UNITED STATES PATENT AND TRADEMARK OFFICE

APPLICATION NO.	FILING DATE	FIRST NAMED INVENTOR	ATTORNEY DOCKET NO.	CONFIRMATION NO.
10/828,637	04/20/2004	Charles Lynn Chidester	14374.54	5324
66358 7590 02/01/2007 VARIAN MEDICAL SYSTEMS TECHNOLOGIES, INC. C/O WORKMAN NYDEGGER 60 E. SOUTH TEMPLE SUITE 1000 SALT LAKE CITY, UT 84111			EXAMINER THOMAS, COURTNEY D	
			ART UNIT 2882	PAPER NUMBER
SHORTENED STATUTORY PERIOD OF RESPONSE 3 MONTHS		MAIL DATE 02/01/2007	DELIVERY MODE PAPER

Office Action Summary	Application No. 10/828,637	Applicant(s) CHIDESTER, CHARLES LYNN	
	Examiner Courtney Thomas	Art Unit 2882

Figure 1 – Cathode assembly – U.S. Patent 5,907,595 to Sommerer

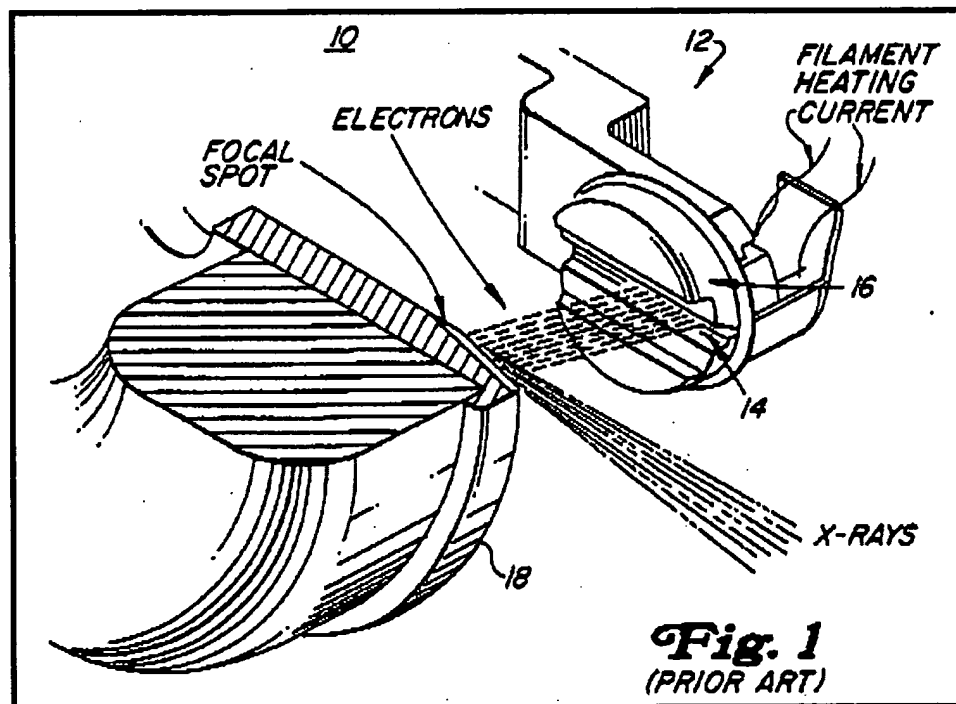
3. As per claim 11, Sommerer discloses a cathode assembly comprising a base (not numbered, see Fig. 1 above) a cathode cup (16) attached to the base portion, the cathode cup including at least two walls which cooperate to at least partially define a slot (see Fig. 1 above); a

filament (14 – column 3, lines 62-67) disposed substantially within a slot. Sommerer does not explicitly disclose the filament as being a helically wound wire whose diameter varies along a longitudinal axis defined by the filament, the variances in diameter being substantially symmetrically arranged with respect to a predetermined location on the longitudinal axis.

Figure 1 – Filament – U.S. Patent 4,959,585 to Hoegler et al.

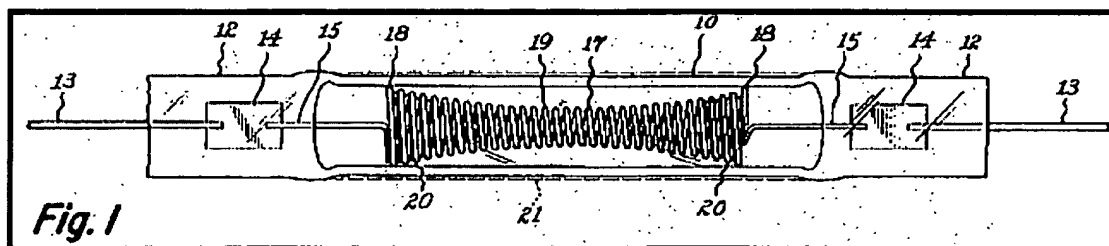
Hoegler et al. disclose a filament (17); a helically wound wire whose diameter varies along a longitudinal axis defined by the filament, the variances in diameter being substantially symmetrically arranged with respect to a predetermined location on the longitudinal axis (see Fig. 1 above). Hoegler et al. teach that such construction enables physical engagement with an electrical connecting portion, while providing support for the filament; as well as controlling irradiation parameters via filament diameter (see also Figs. 1a, 1b, 3 and 5, not shown above; column 7, lines 25-50).

It would have been obvious to one having ordinary skill in the art at the time the invention was made to modify the cathode assembly of Sommerer such that it incorporated the filament of Hoegler et al. One would have been motivated to make such a modification for the purpose of providing a filament that enables physical engagement with an electrical connecting portion, while providing support for the filament; as well as controlling irradiation parameters via filament diameter, as taught by Hoegler et al. (column 7, lines 25-50).
